### Proposed Revisions to a Standard Plans Index

Index Number: 700-010

Sheet Number (s): 1, 4, 6, 7, and 8 of 11

Index Title: Single Column Ground Signs

GENERAL NOTES AND DESIGN EXAMPLE

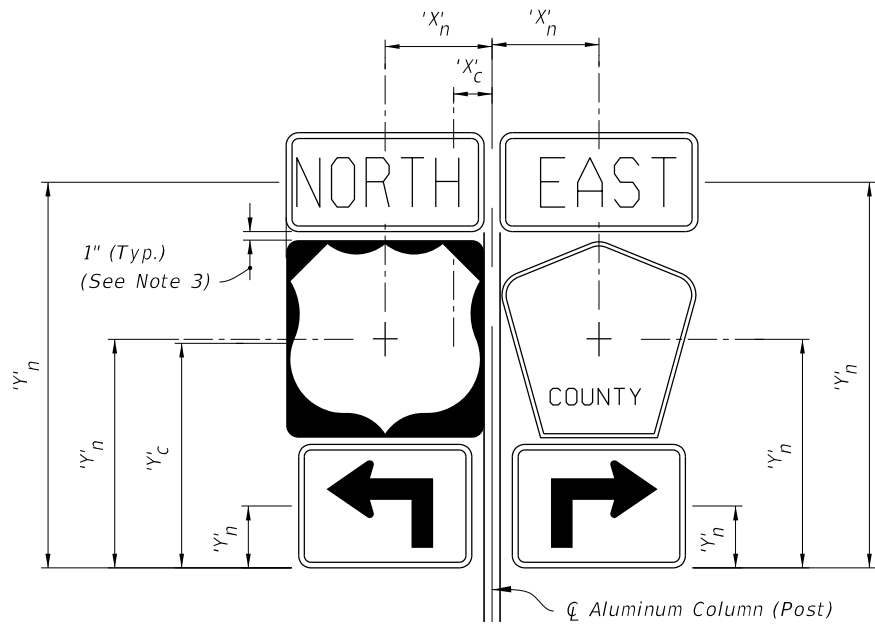
Sheet 1: Added New Note 1 - "Meet the requirements of Specification 700"; Delete General Notes 2 through 7; Renumber General Notes.

ADDED NEW NOTE 1:

GENERAL COMMENT: Material information was deleted. Information is either already covered in Standard Specifications OR will be added to Section 700, 962 or 965 in conjunction with these revisions.

DELETED

**SLIP BASE AND FOUNDATION DETAIL**  
(Non-Frangible Column, Typ.)

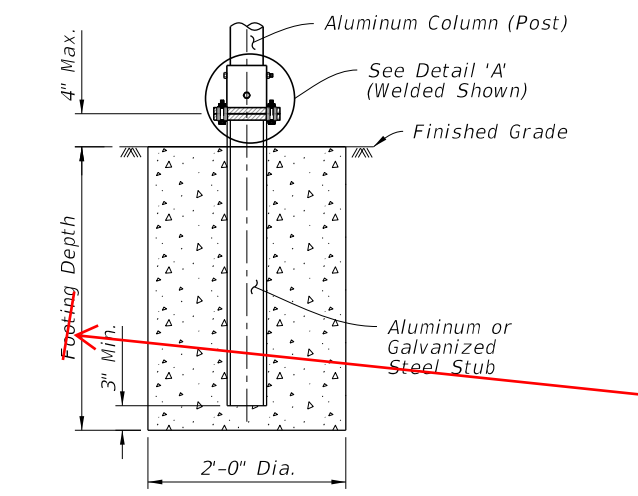
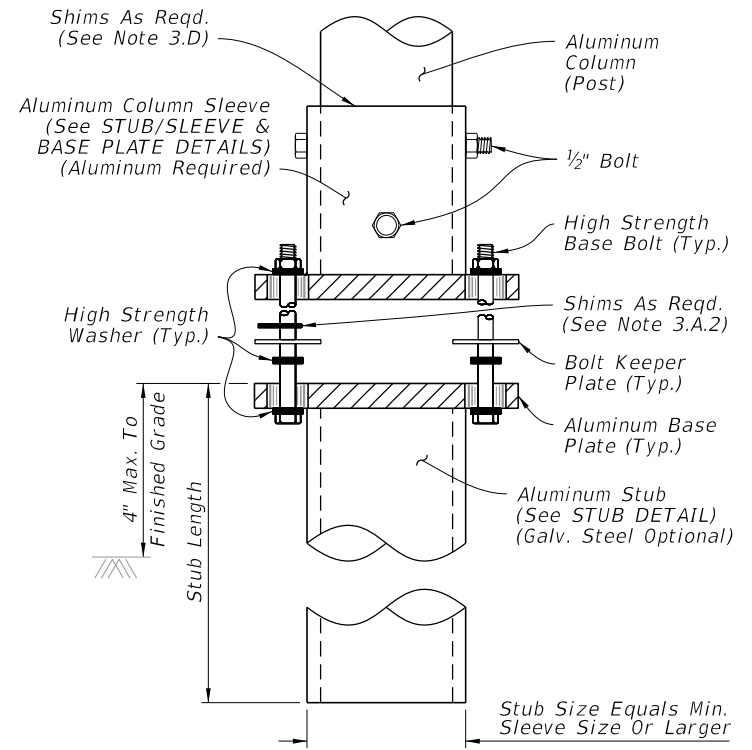
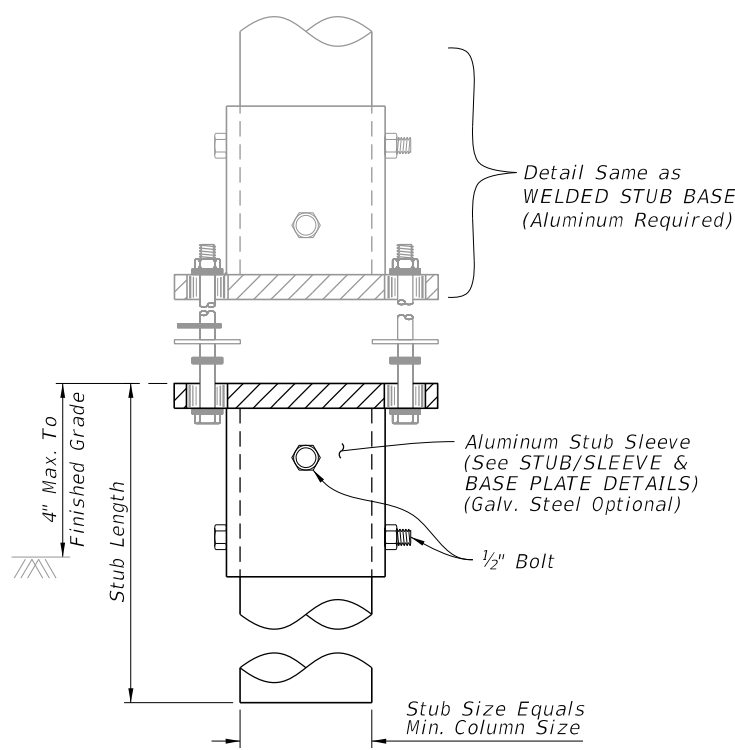
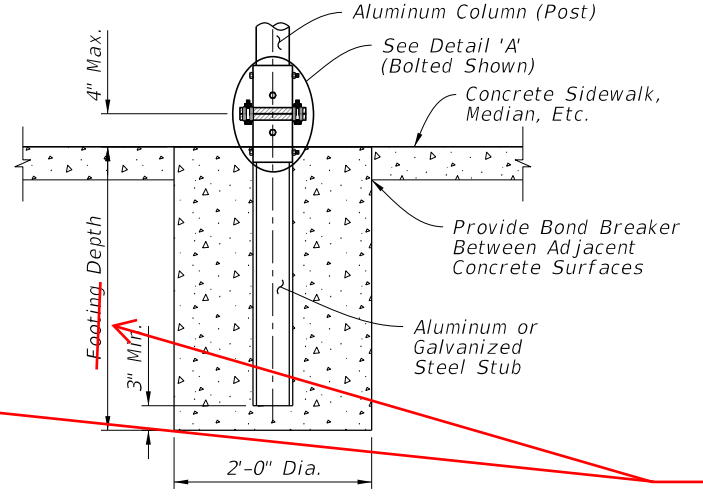
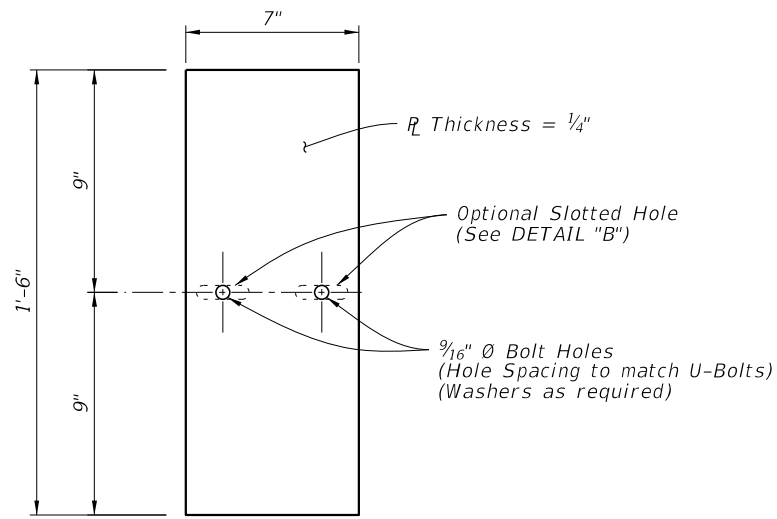
Sheet 4: Updated Note 1.A. - Deleted Concrete Class; See FOUNDATION TABLE on Sheet 3 for foundation embedment depth and stub length.

**UPDATED NOTE:**  
See FOUNDATION TABLE on Sheet 3 for foundation embedment depth and stub length.

- Foundation Notes for Slip Base:
  - ~~Place Stub into concrete foundation given in the FOUNDATION TABLE using Class II Concrete.~~
- Slip Base Fabrication Notes:

- Foundation Notes for Slip Base:**
  - See FOUNDATION TABLE on Sheet 3 for foundation embedment depth and stub length.
- Slip Base Fabrication Notes:**

**WIND BEAM CONNECTION**

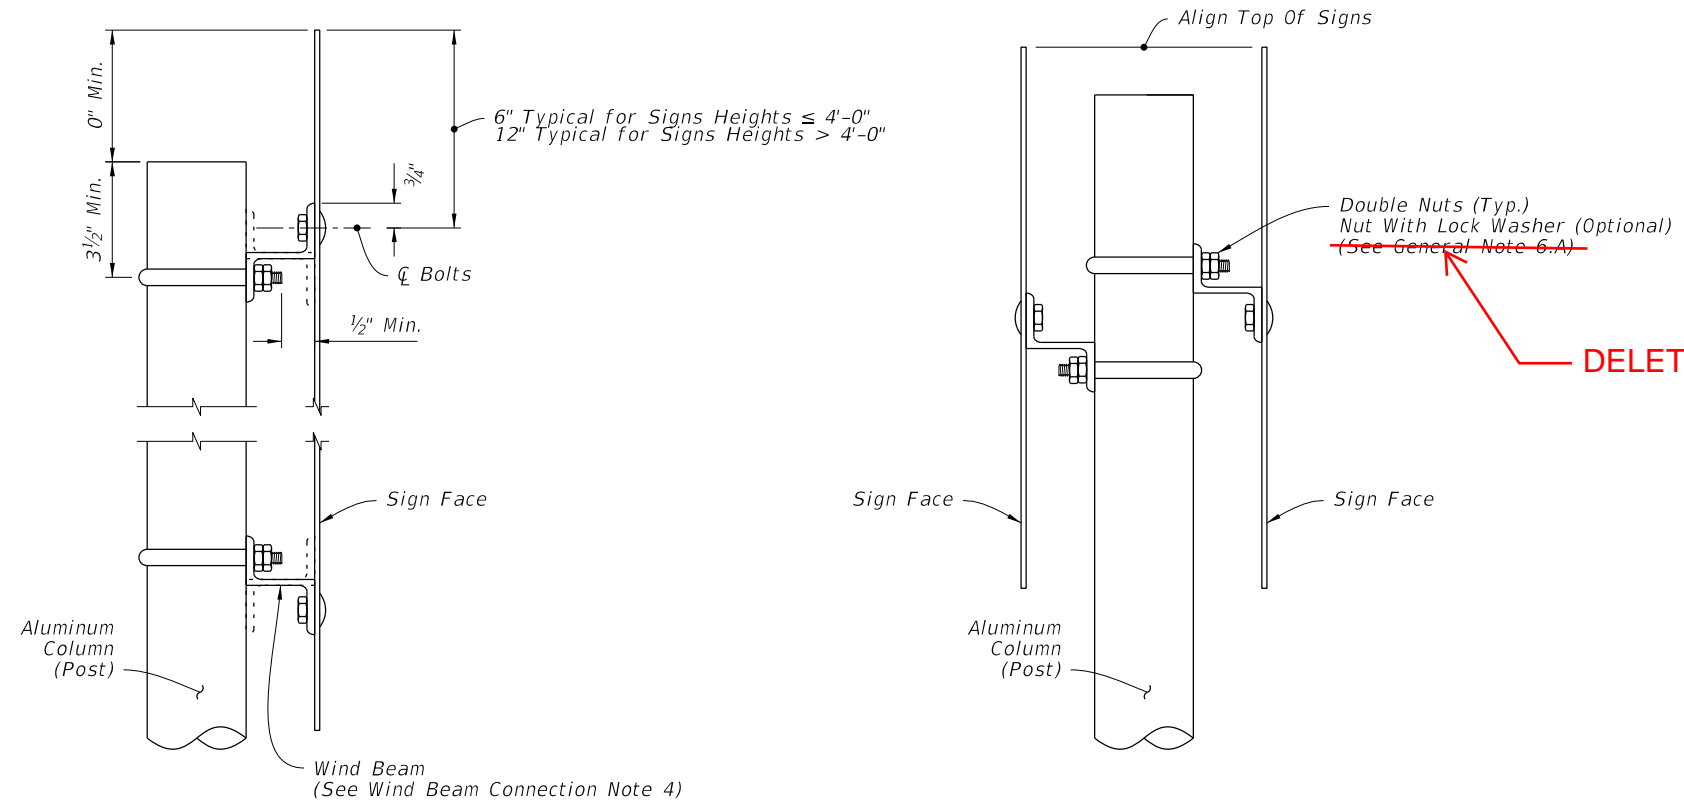
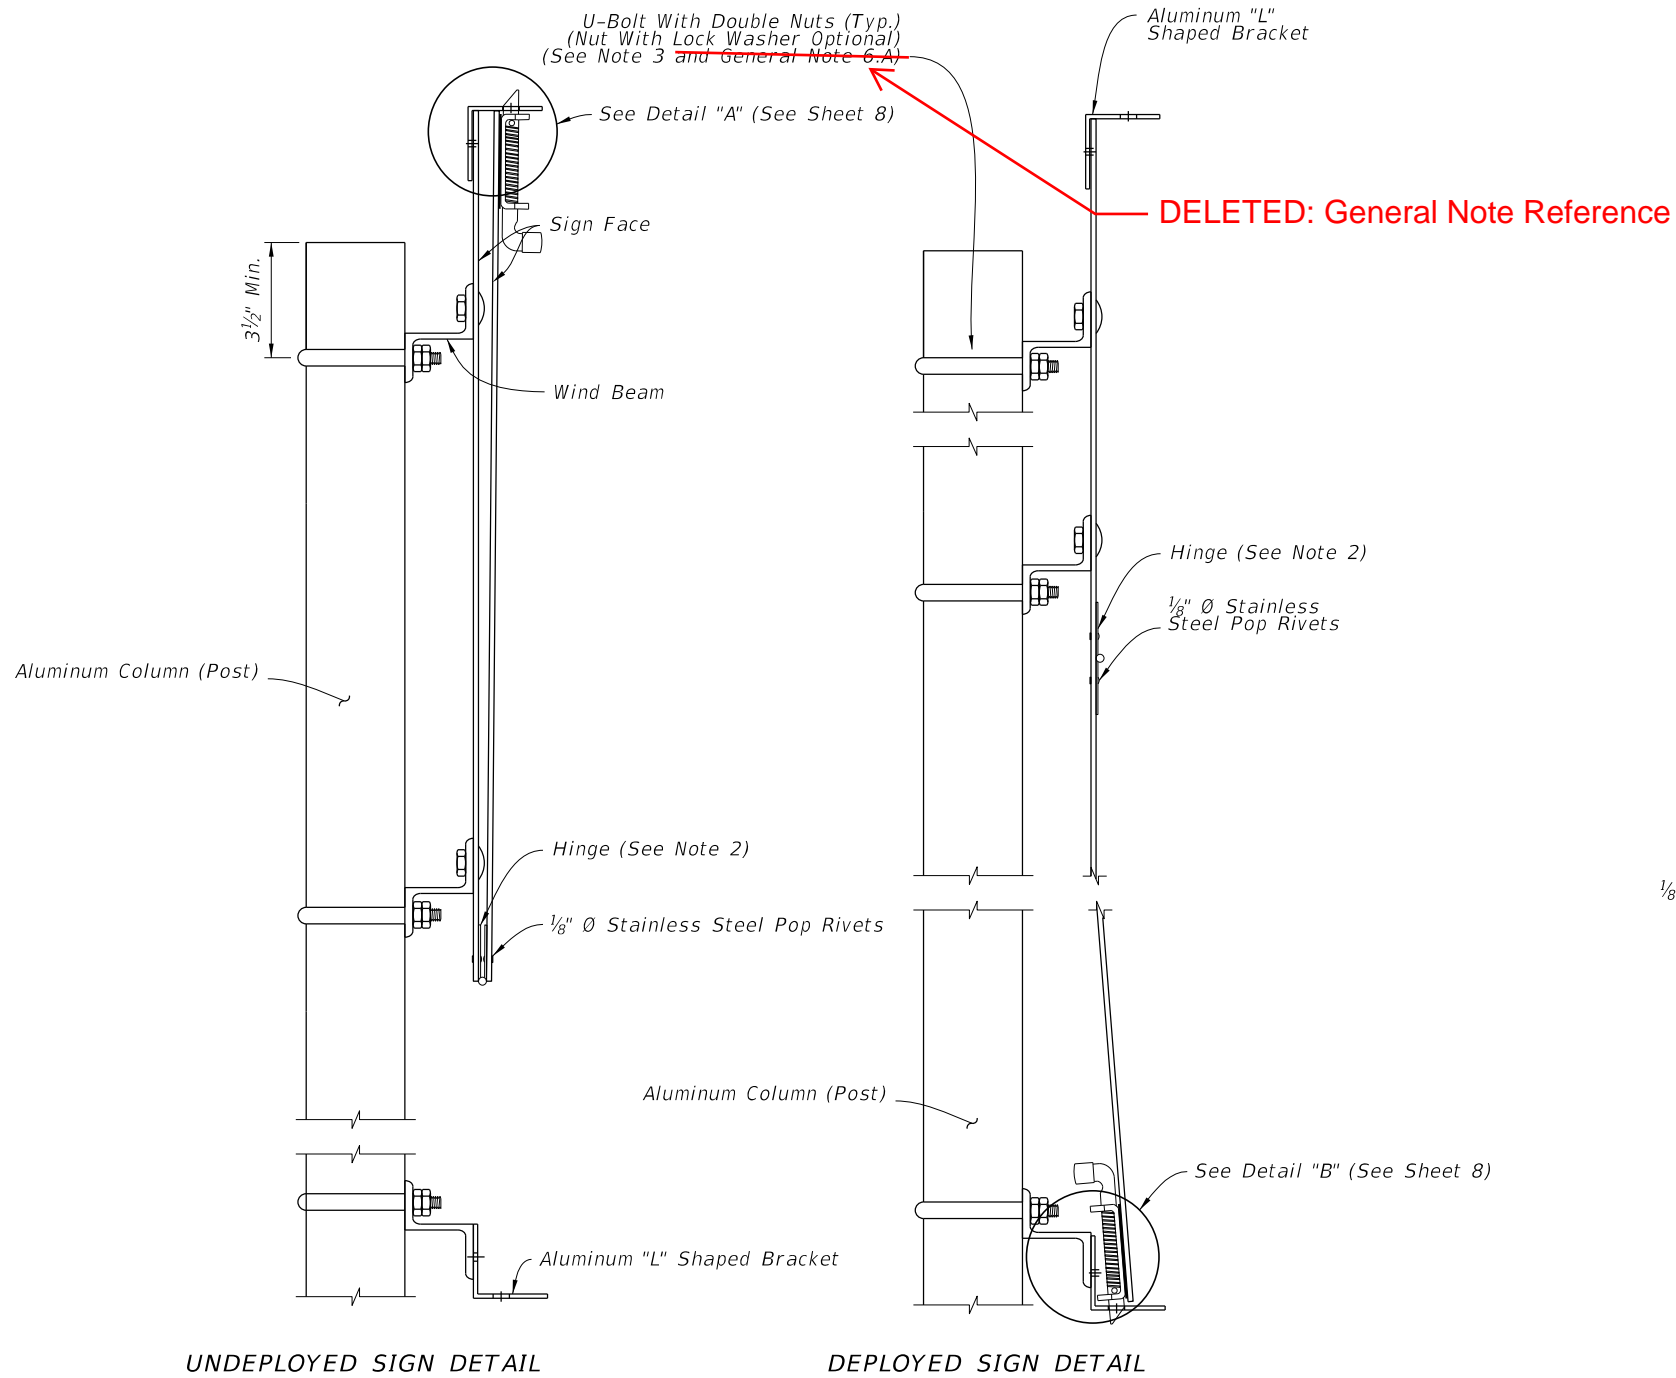
Sheet 6: Deleted General Note reference in the BACK-TO-BACK SIGN DETAIL.

WIND BEAM CONNECTION FOR FLIP DOWN SIGN

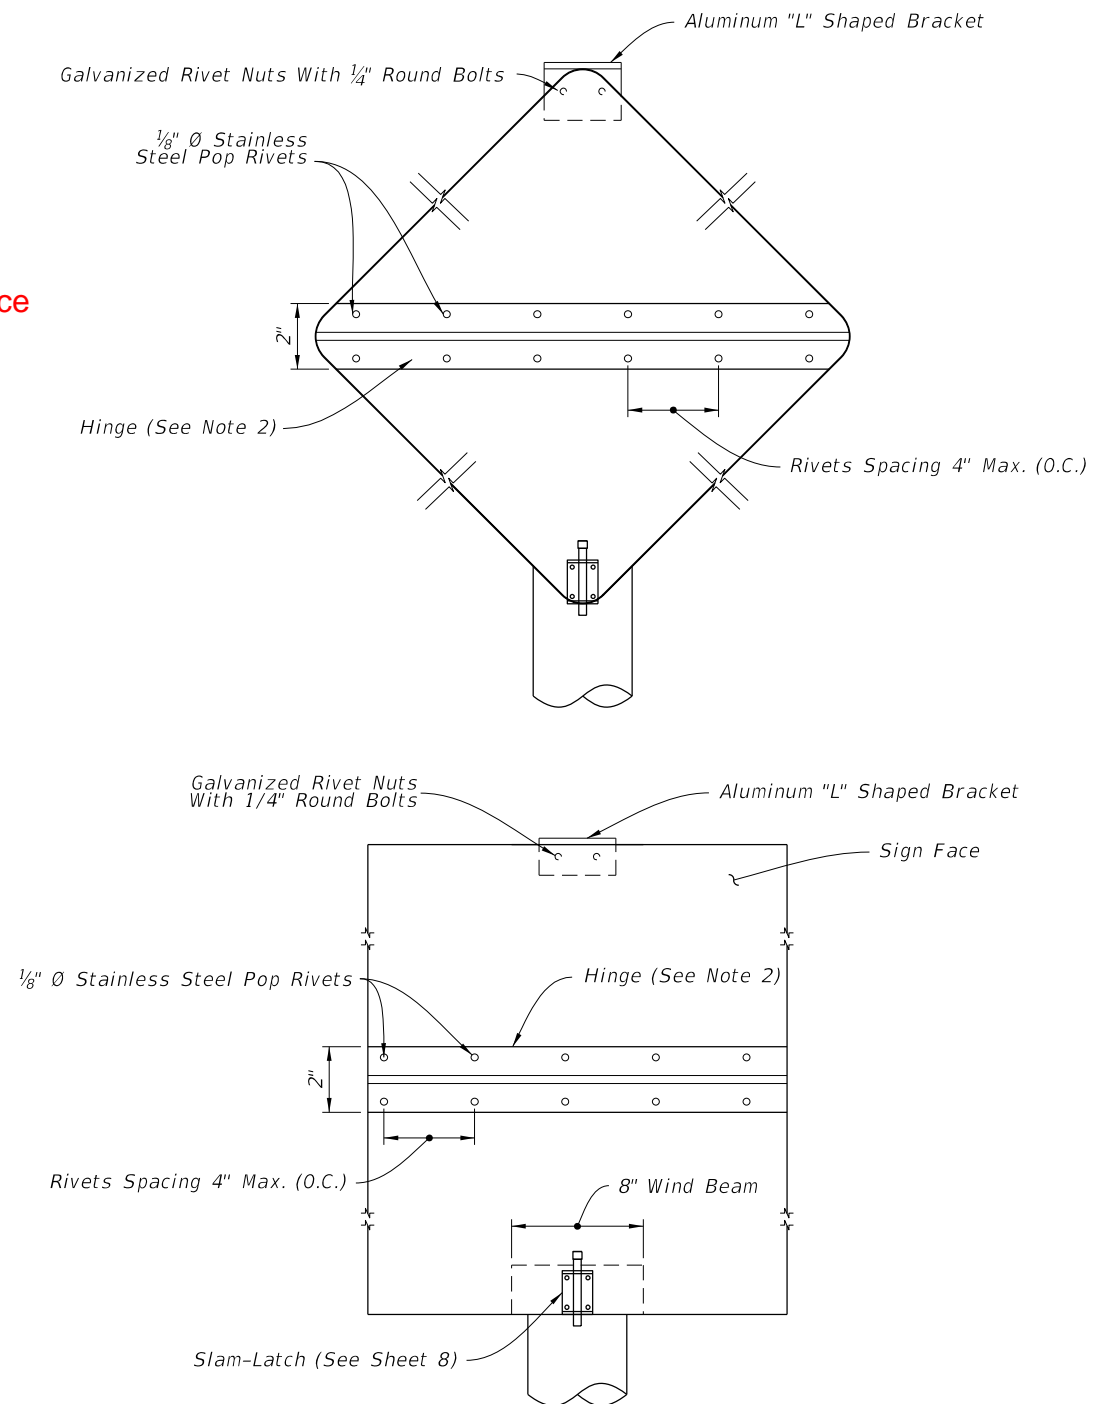
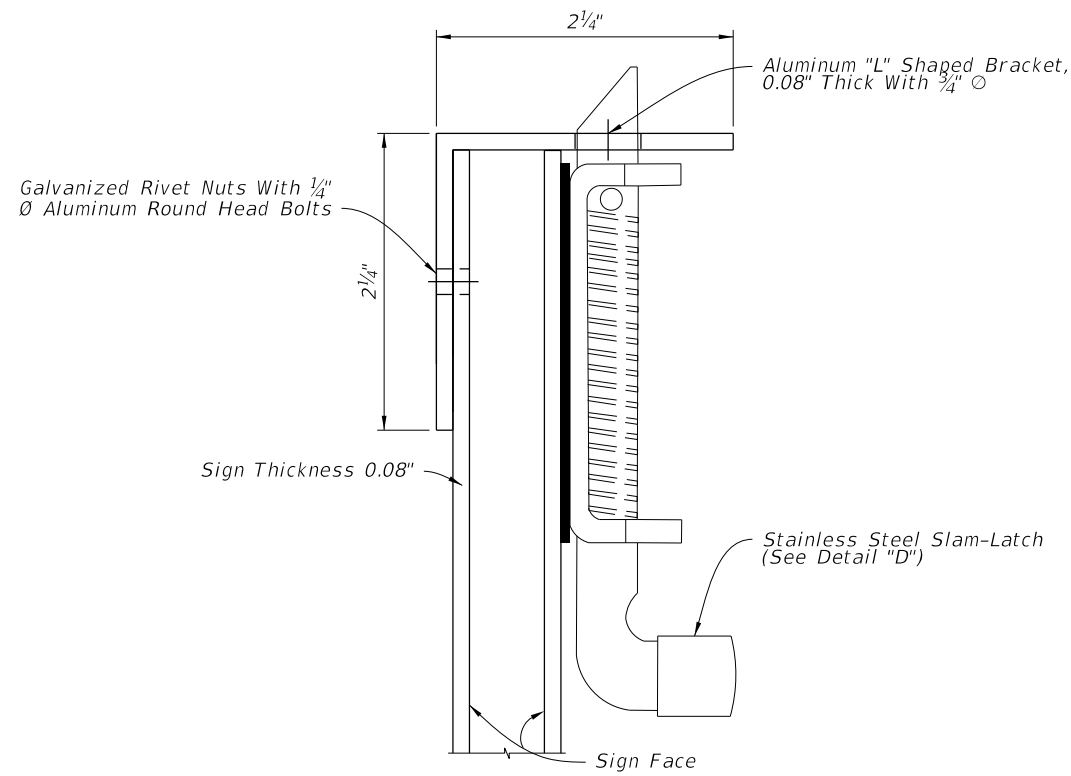
Sheet 7: Deleted General Note references in the SIGN PANEL SIDE VIEW details.

DETAIL "B"

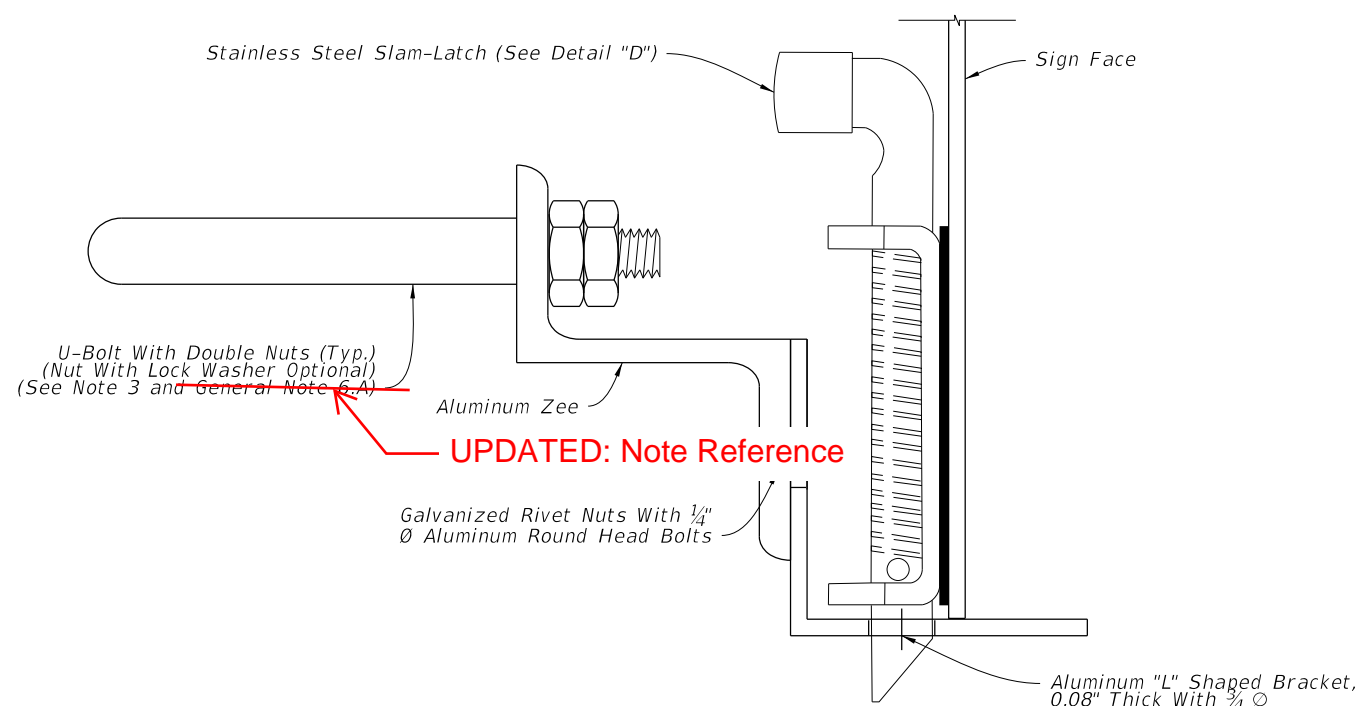
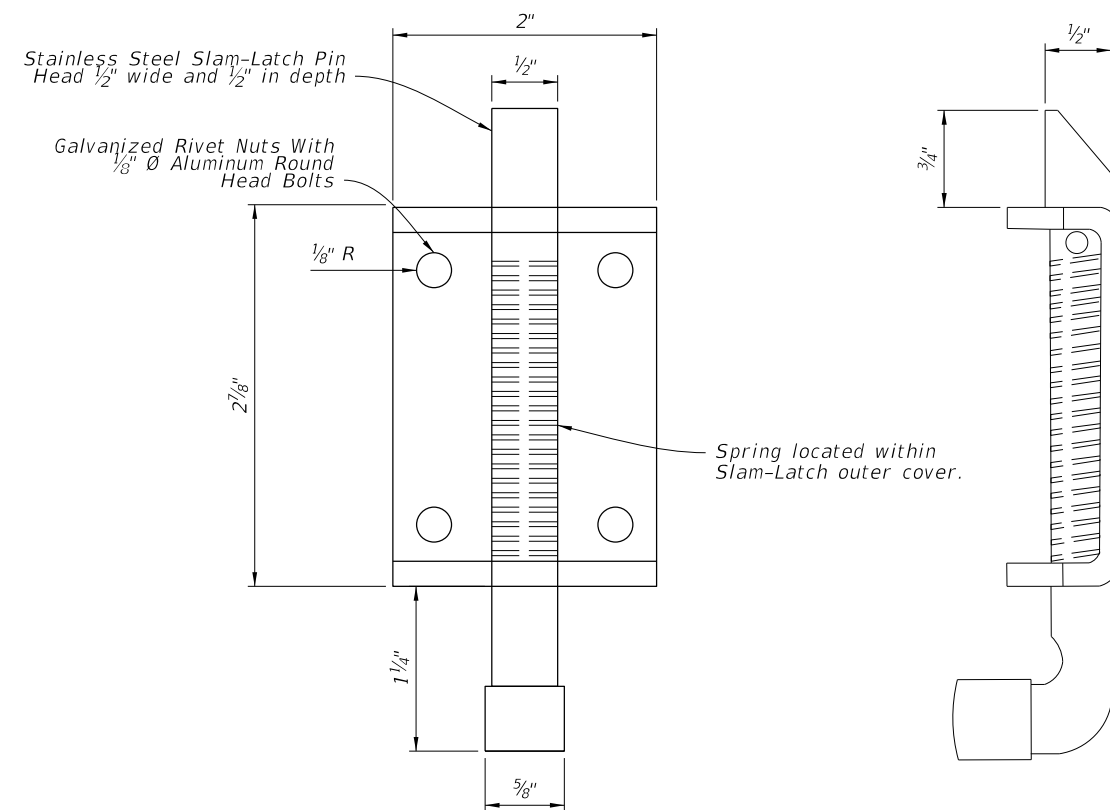
Sheet 8: Deleted General Note reference in Detail"B".
